Logan-Union-Champaign regional planning commission

Zoning & Subdivision Committee

Thursday, December 14, 2017

Staff Report – Darby Braeside

NO.		DATE		BY		DESCRIPTION	
1160 DUBLIN ROAD, SUITE 100		COLUMBUS, OH 43215		TEL: 614-414-1225		FAX: 614-414-1226	
PROJECT NO. 0326001		PROJECT DATE: 11/07/2017		DRAWN BY: DJ		CHECKED BY: RV	
CITY OF PLAIN CITY, OHIO		DARBY BRAESIDE, LLC		DARBY BRAESIDE, LLC		UNION COUNTY OHIO	
GRADING PLAN		10		19

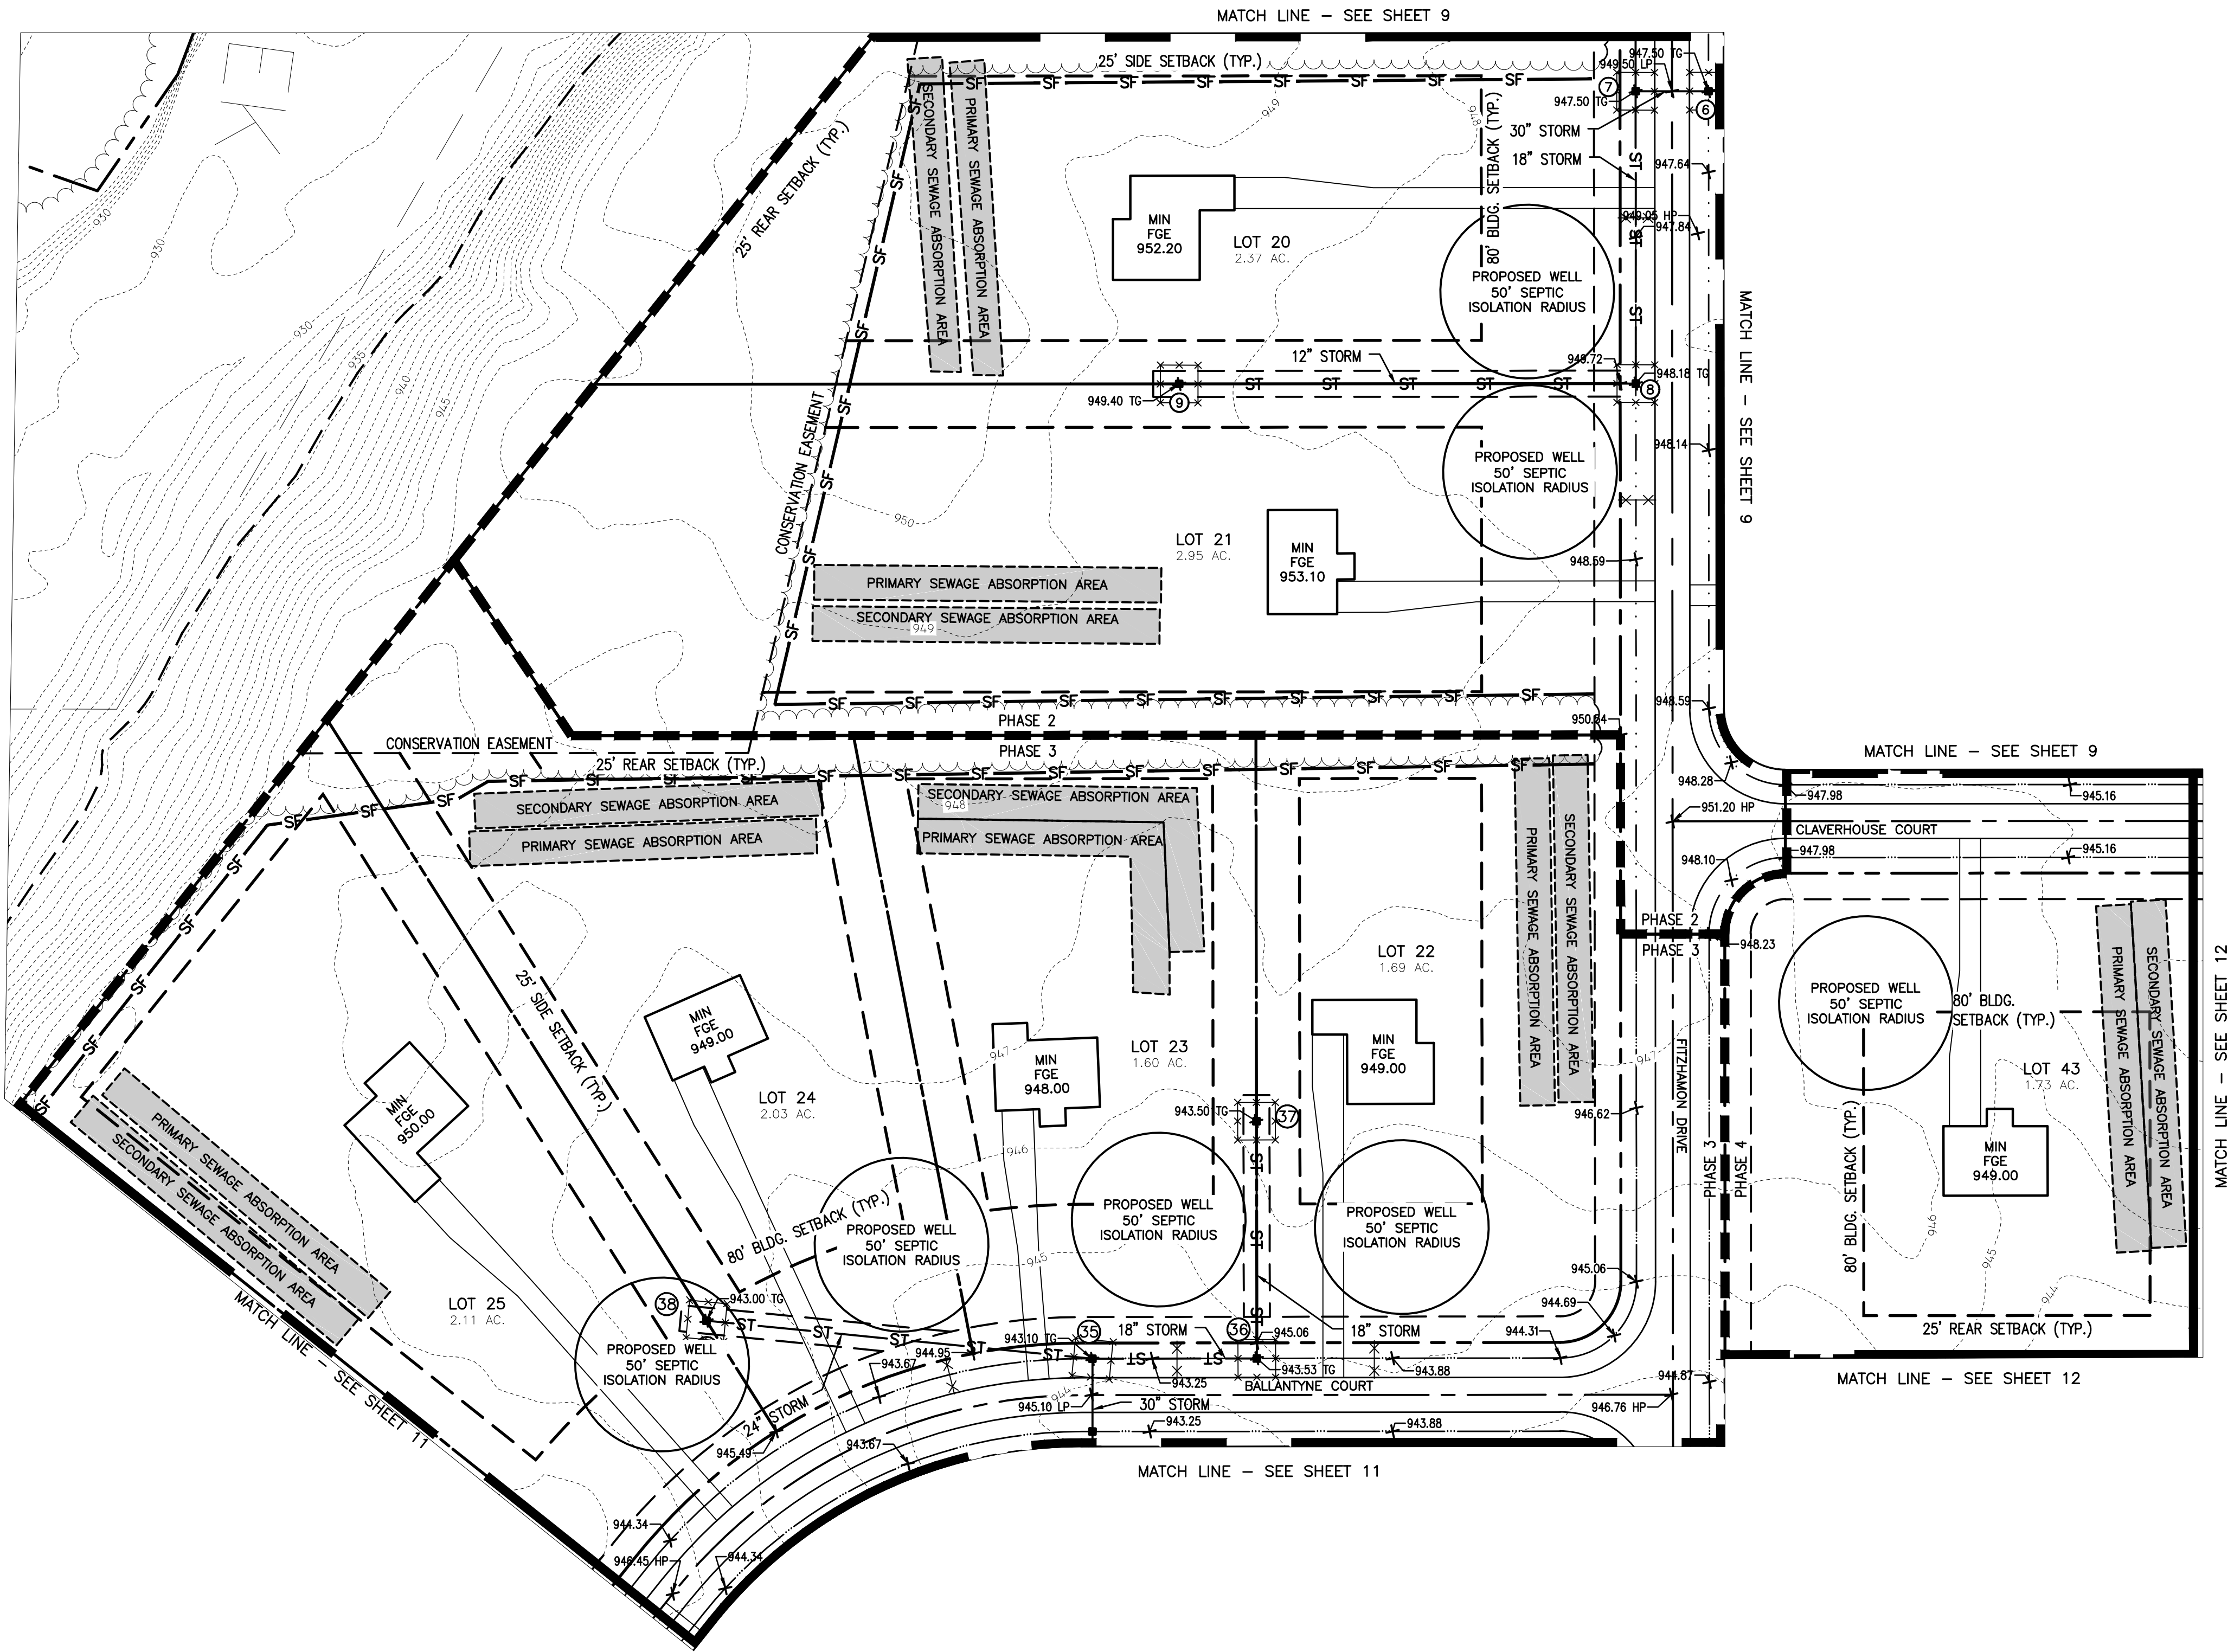
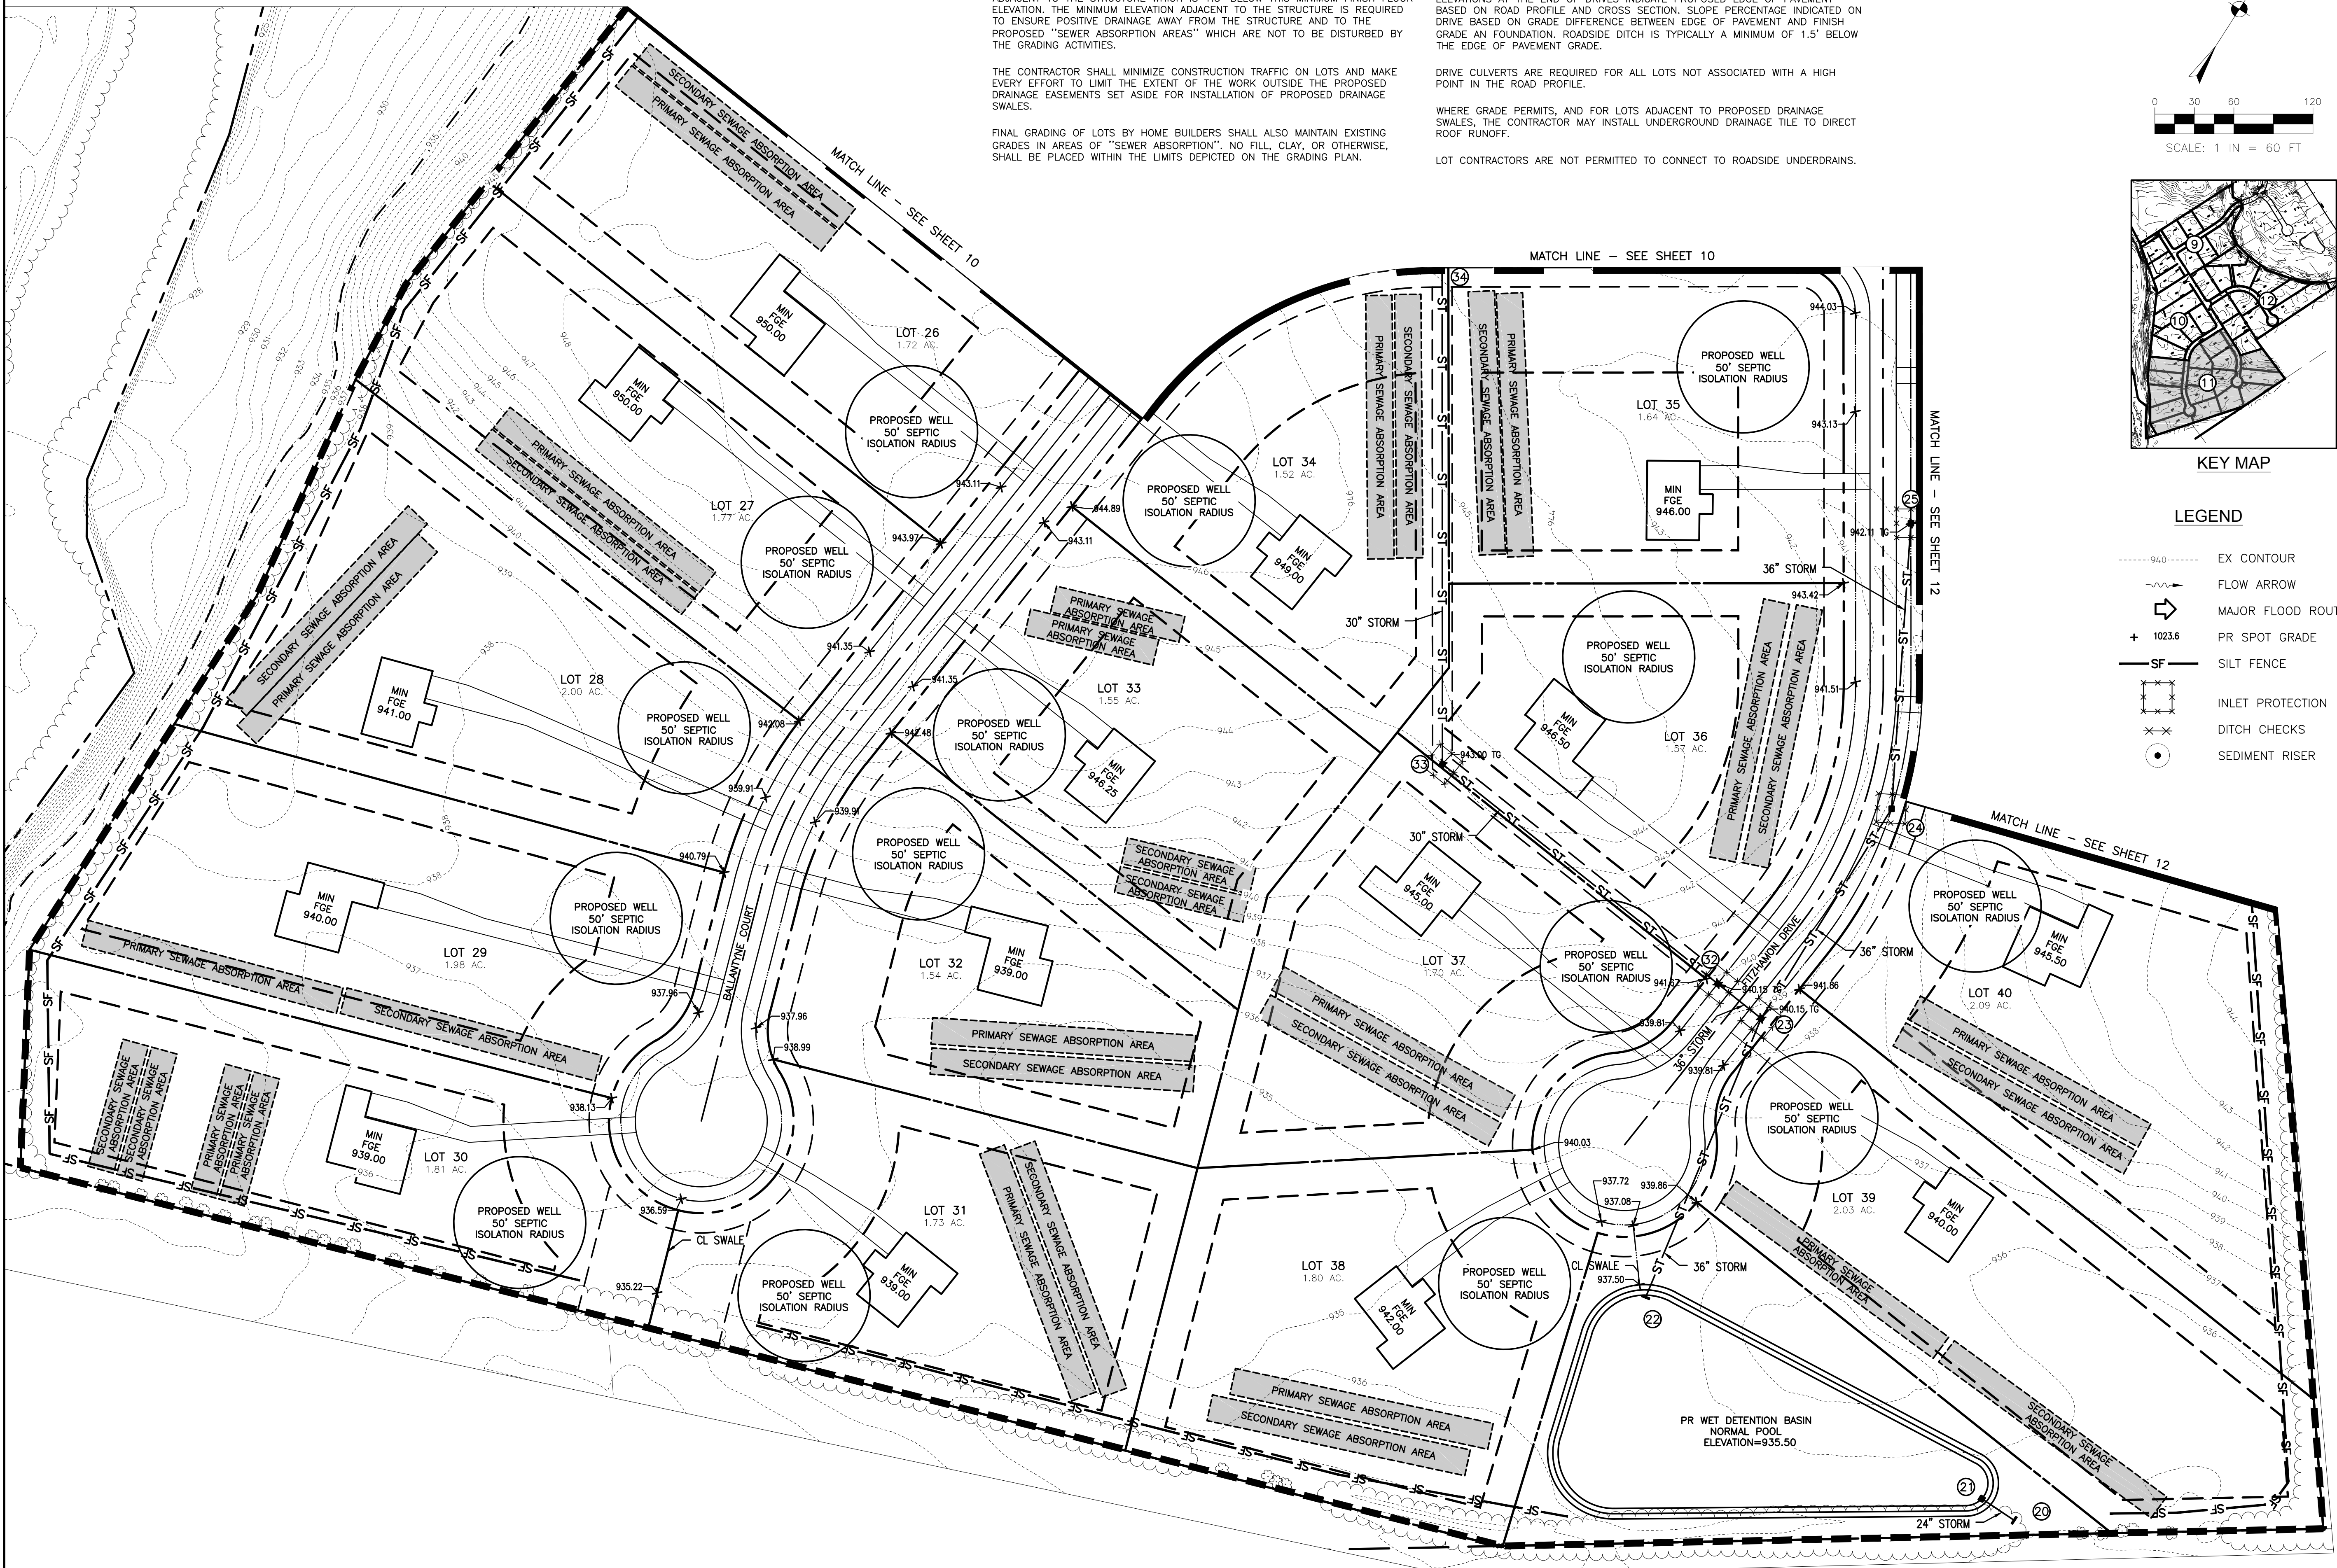
- 5) Sheet 9-12 of 19 – Site and Grading Profiles
 - a) With the amount of allocated space for storm, sewage and water wells UREC will need to work with developer engineering firm to establish offset easements between lots for primary or secondary facilities.

- b) Concerns with sewage absorption area with utility easements for Lots: 12, 16, 22, 43, 29, 34, 35, 36, 37, 39, 44 and 45.
- 6) Sheet 13-14 of 19 – Storm Sewer Profiles
